SECTION 009113 – ADDENDUM TWO

- A. Project Name: 22034.02 Meridian High School
- B. Owner: Meridian Public School District, 1019 25th Avenue, Meridian, MS 38391
- C. Architect: Dale | Bailey, an Association, One Jackson Place, Suite 250, 188 East Capitol Street, Jackson, MS 39201-2100
- D. Architect Project Number: 22034.02
- E. Date of Addendum Two: 7 September 2023

3 MOMENT FRAME CONNECTION DETAILS
AT HSS TUBES

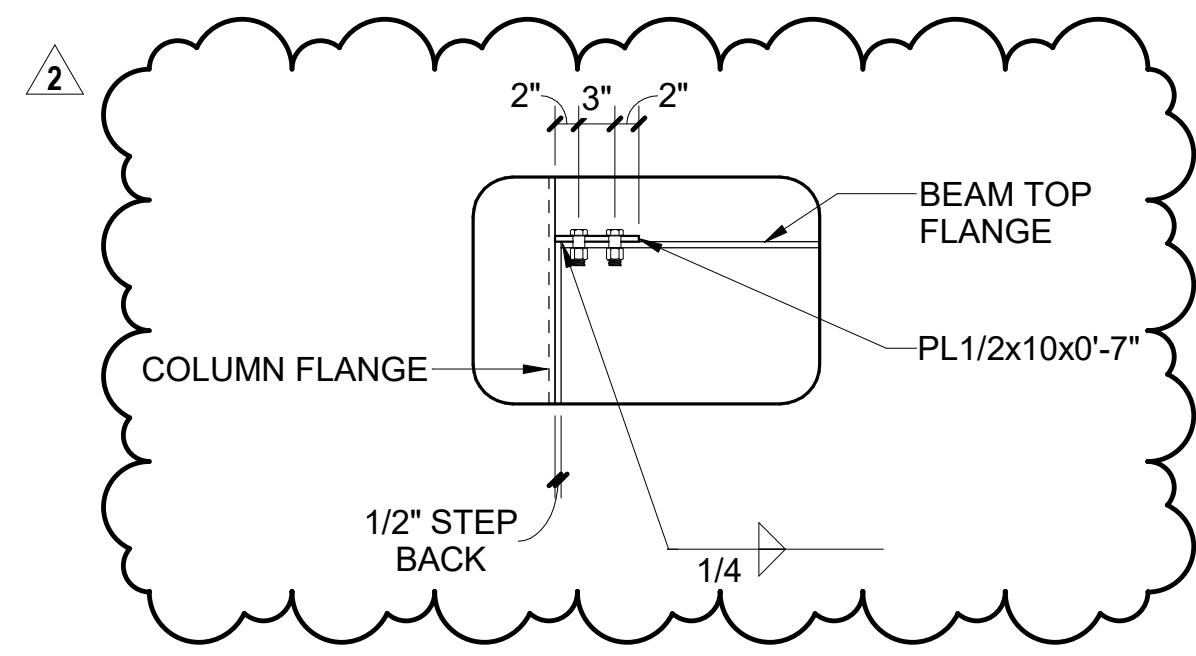
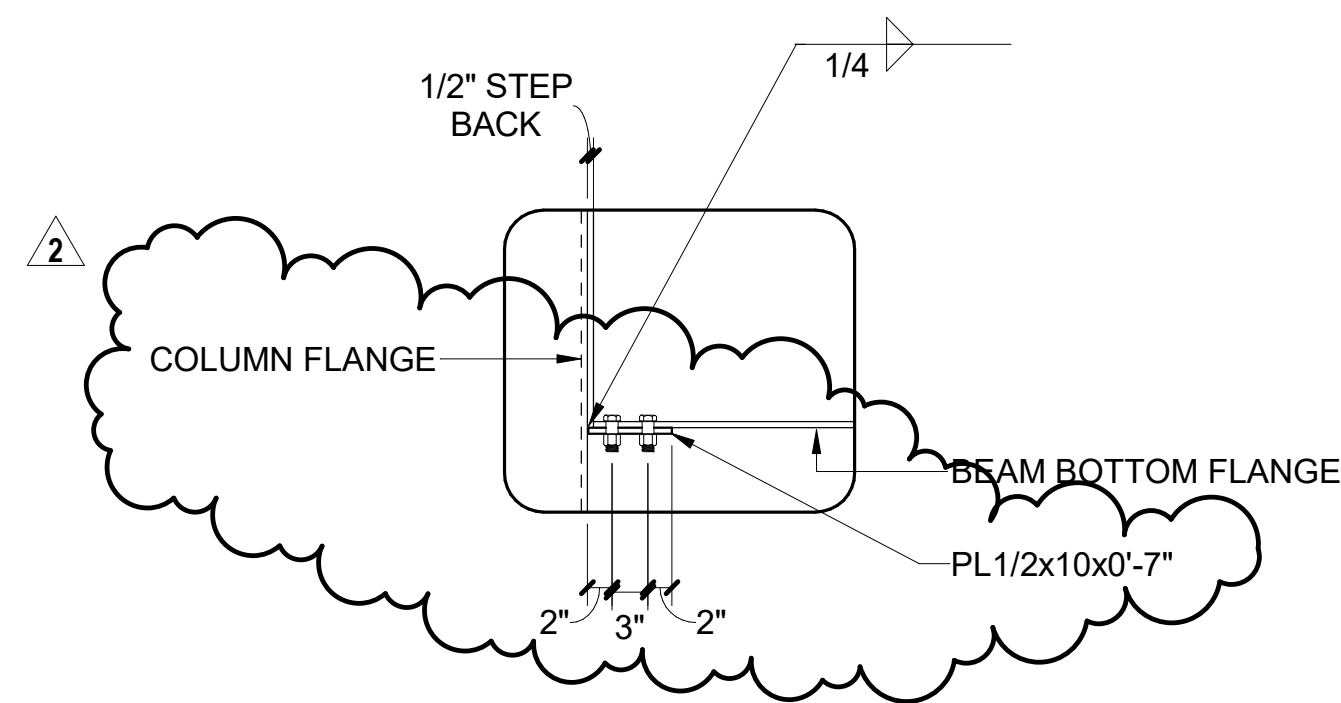
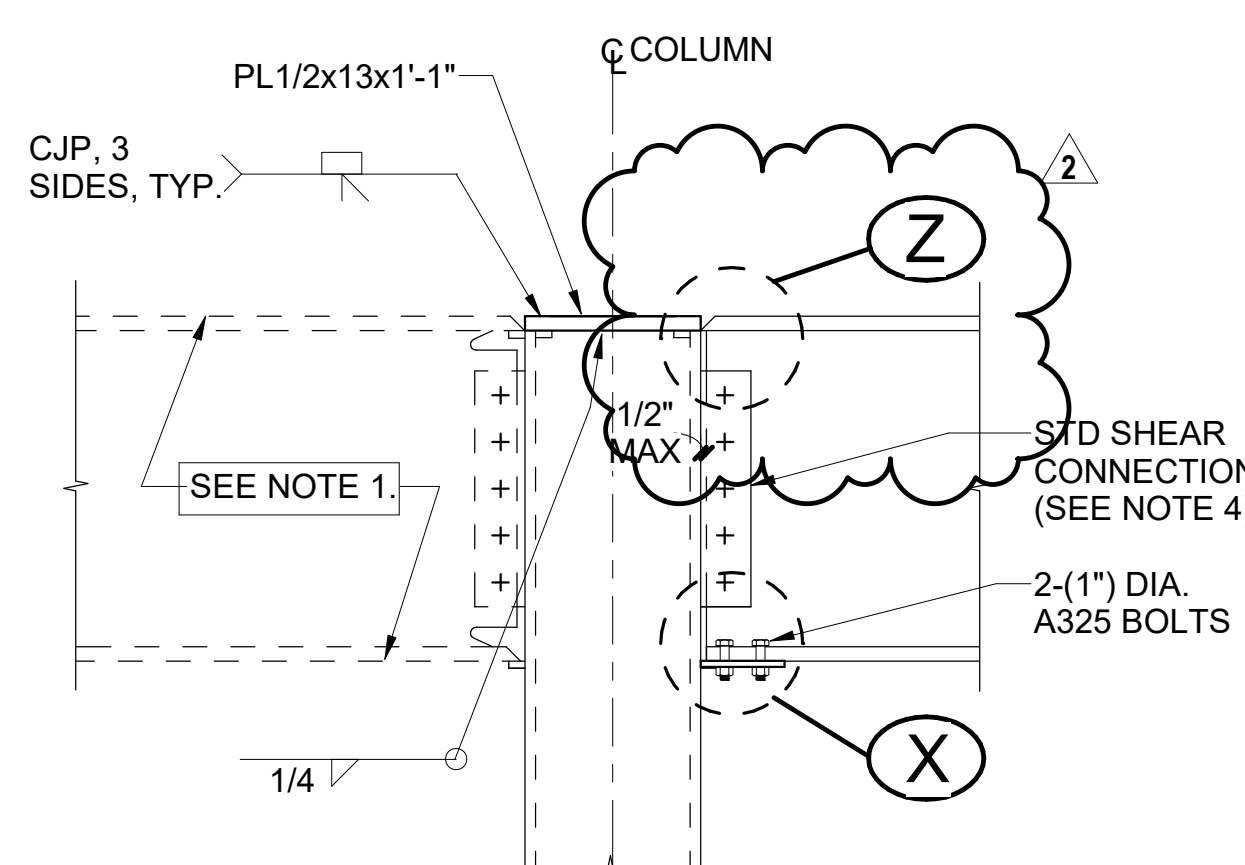
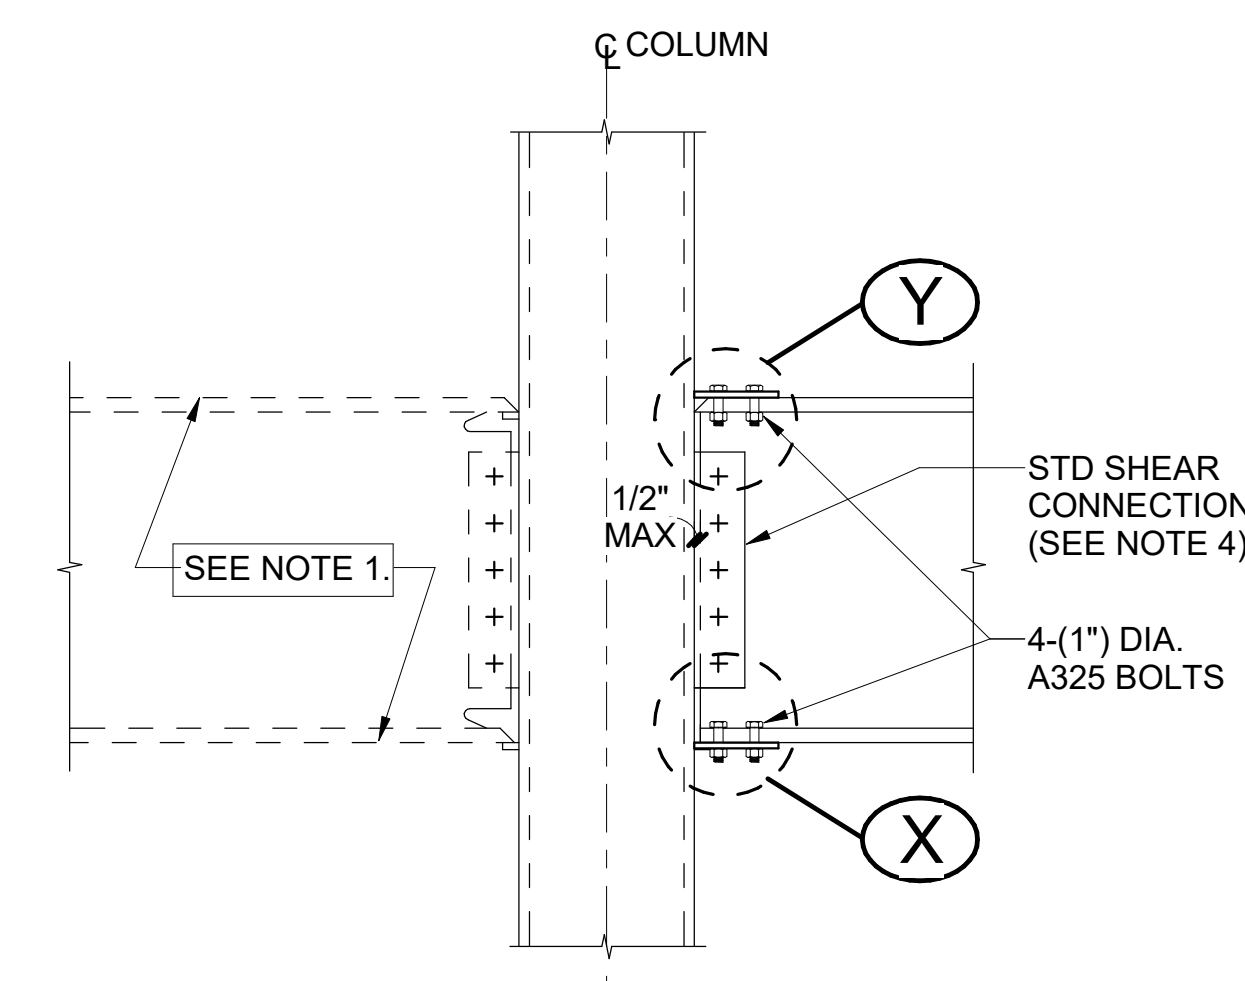
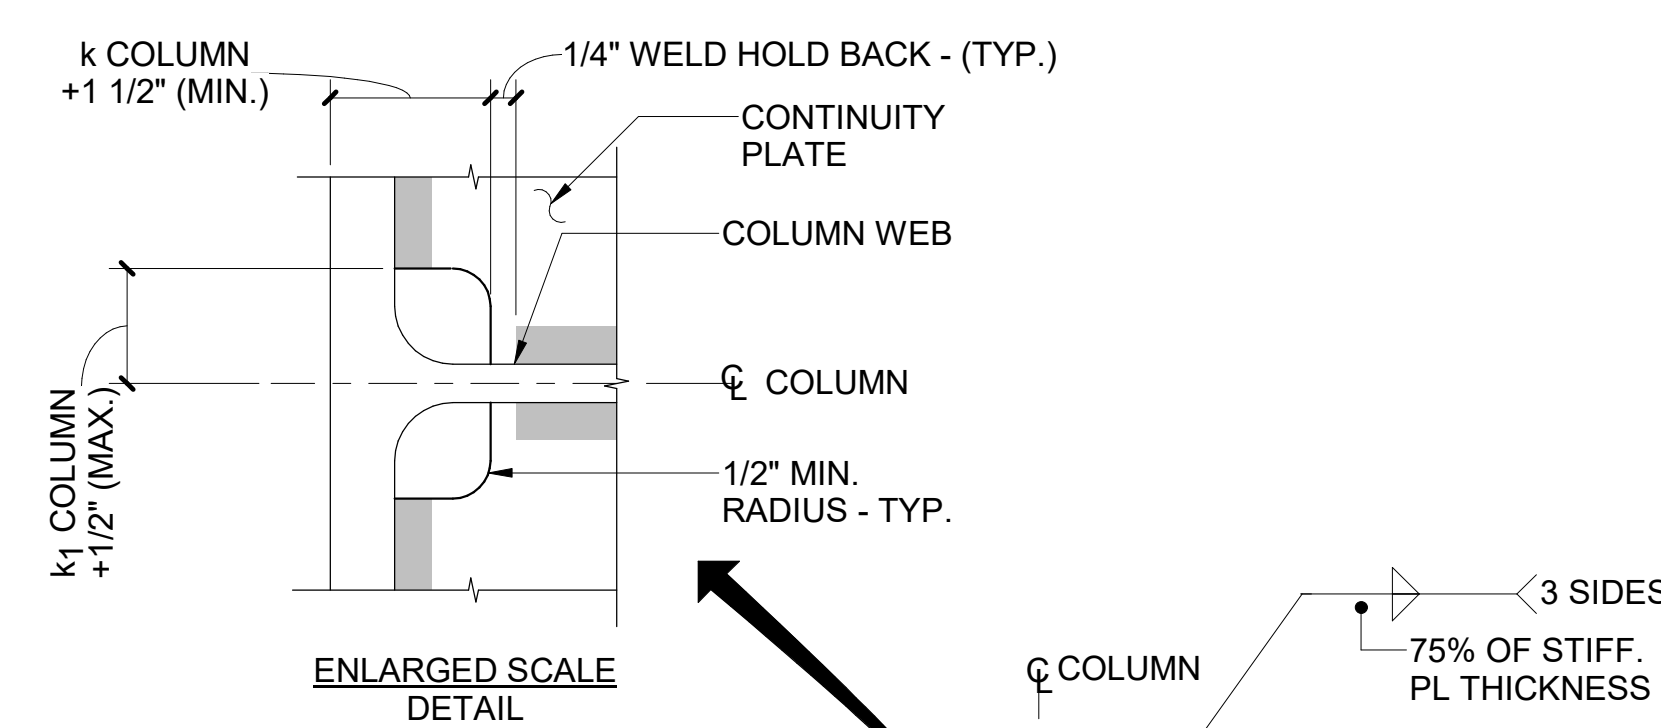
- B. Sheet S-600 – Moment Frame Sections & Details. (Revised). Delete this sheet in its entirety and replace it with attached. Revised Detail 1 with updates to baseplates. Revised Detail 3 to Clarify Moment Fame Connection.
